CITY OF ALBUQUERQUE

**Re: Lot 18 Block 38 Volcano Cliffs Subd. SAD 228
6636 Sujeto Rd NW
Grading & Drainage Plan
Engineer's Stamp dated: 4-28-19 (D10D003K15)
Revised for pool Date: 4-28-19**

Lots 15, Block 5, Volcano Cliffs Subdivision, Unit 18
6636 Sujeto Road, NW, POOL/SPA ADDITION
GRADING PLAN

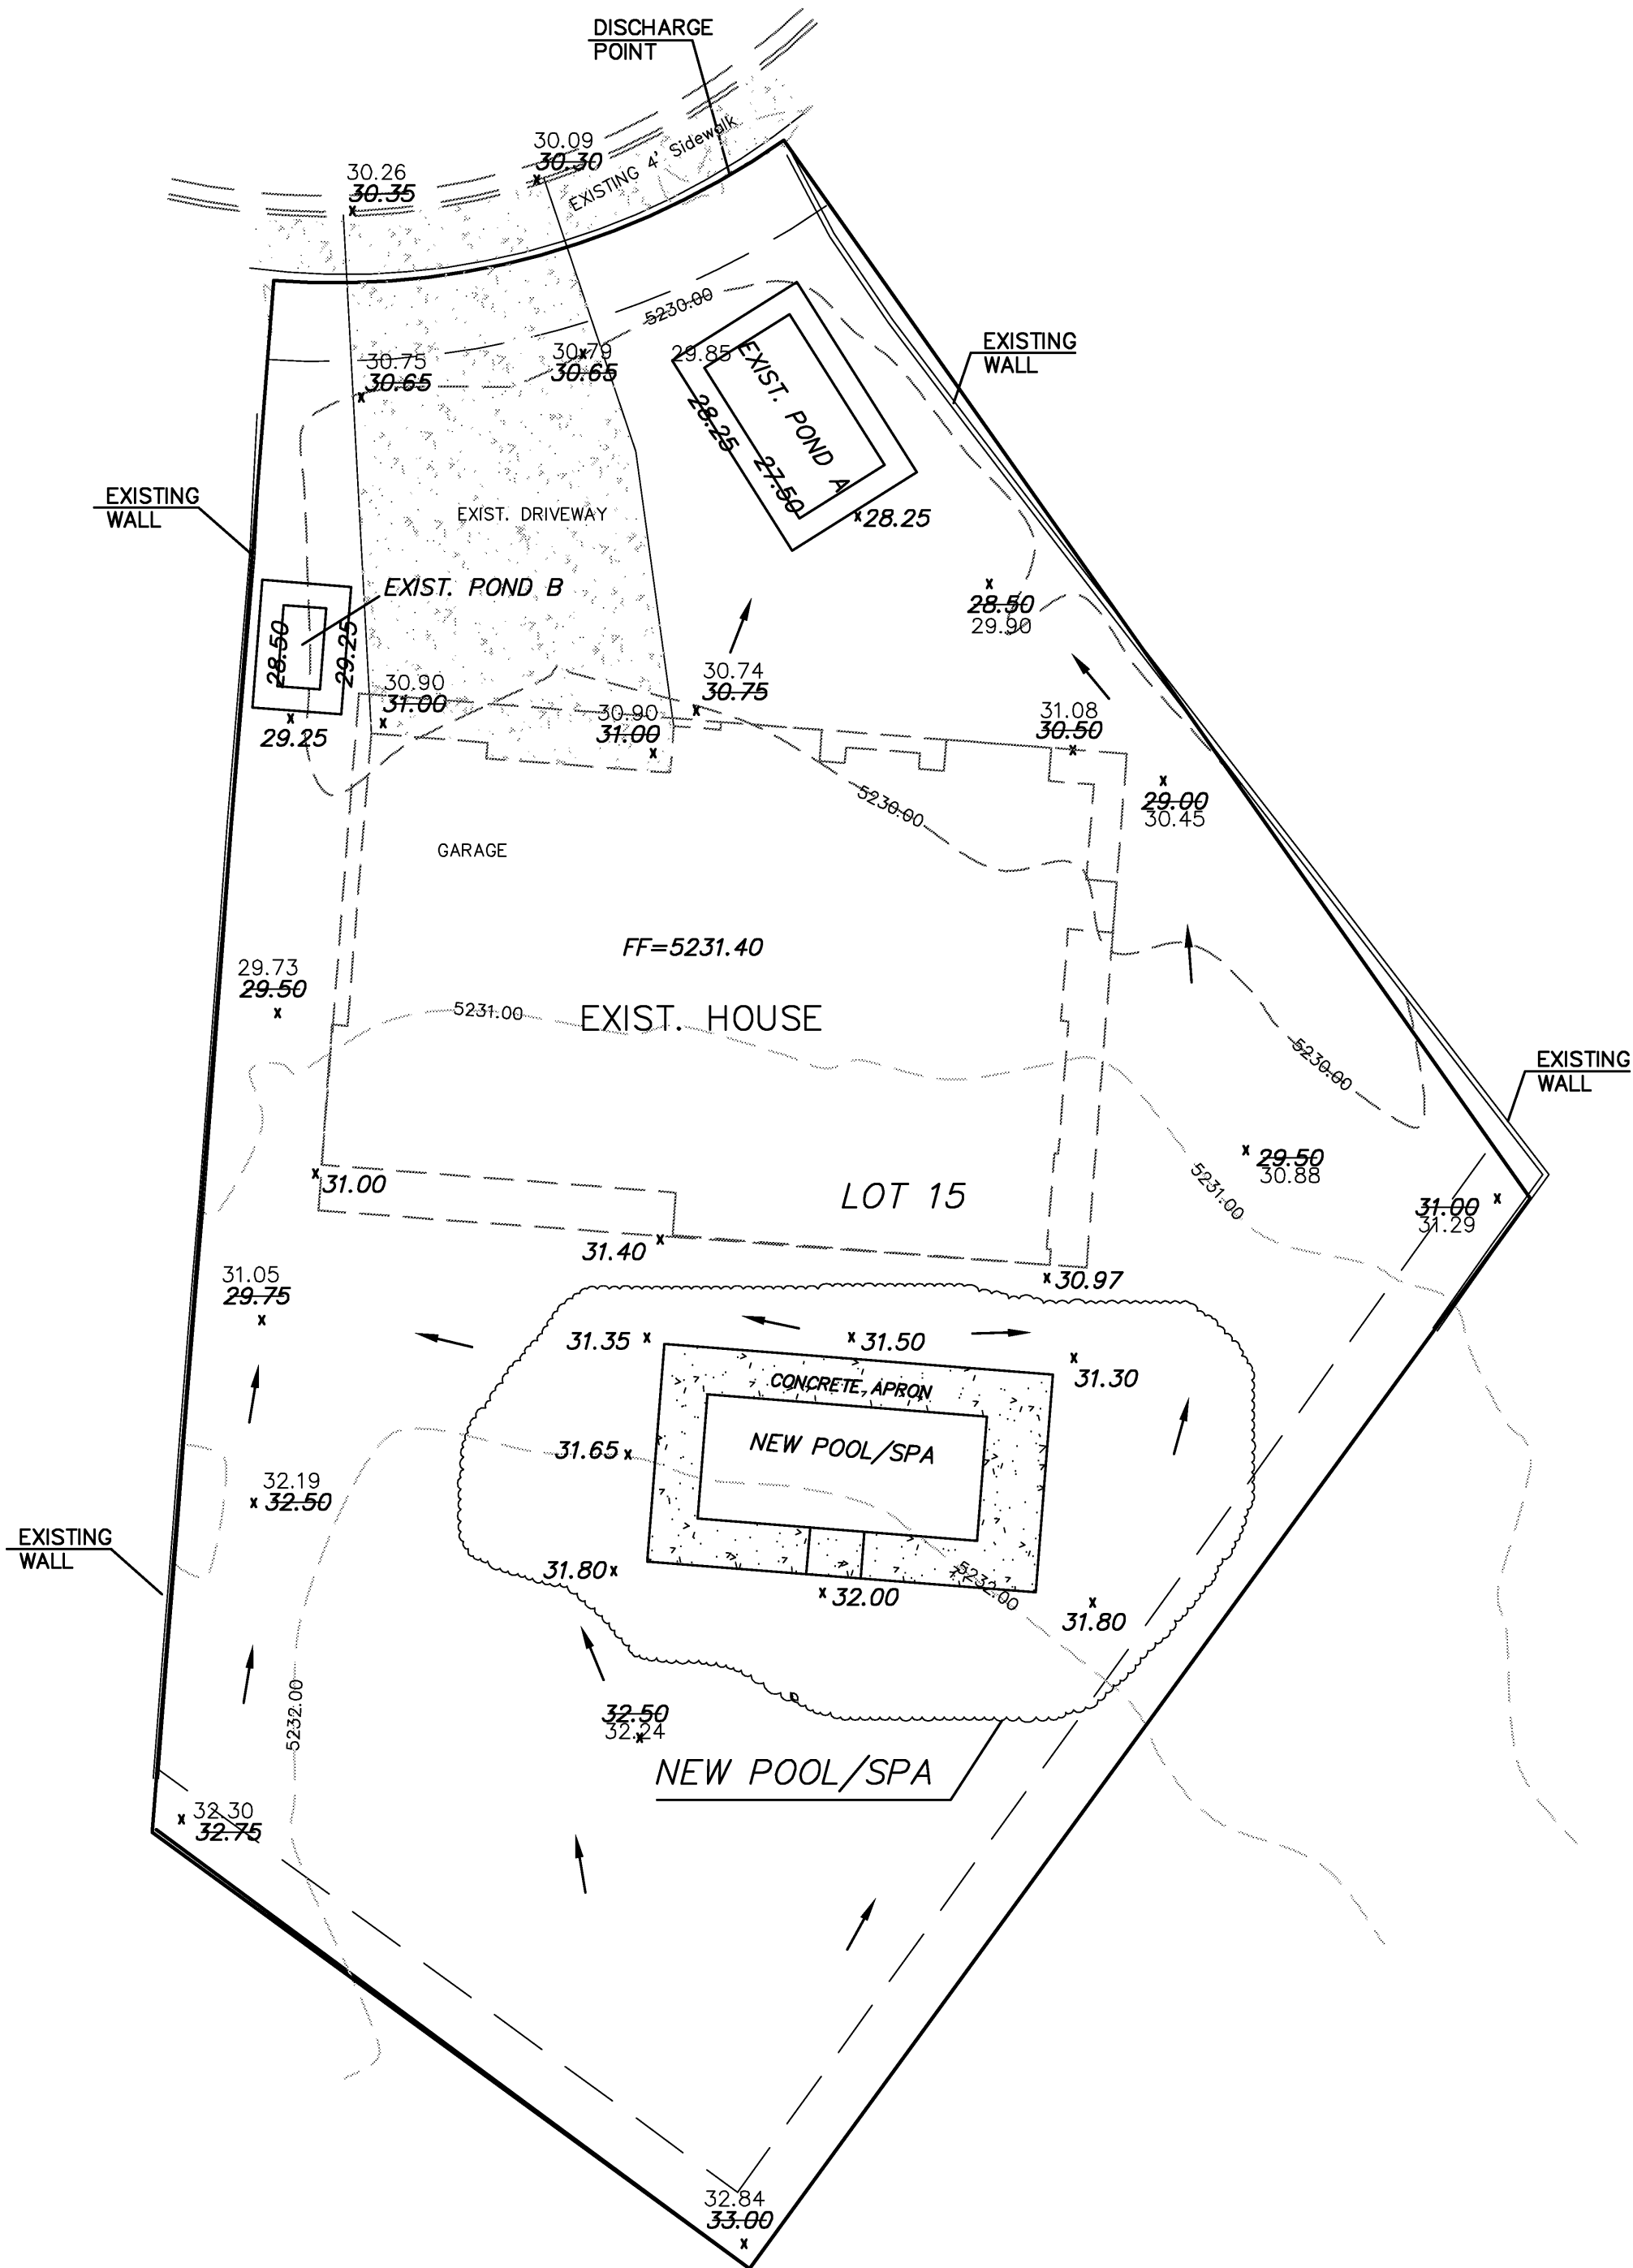
Based upon the information provided in your submittal received 6/21/2021, this plan is cannot be approved for Grading Permit until the following comments are addressed.

- The approval date is the same as the original approved date. Provide a new approval date with a note stating the changes.
- Provide the new land treatment amounts in red along with the original land treatments.
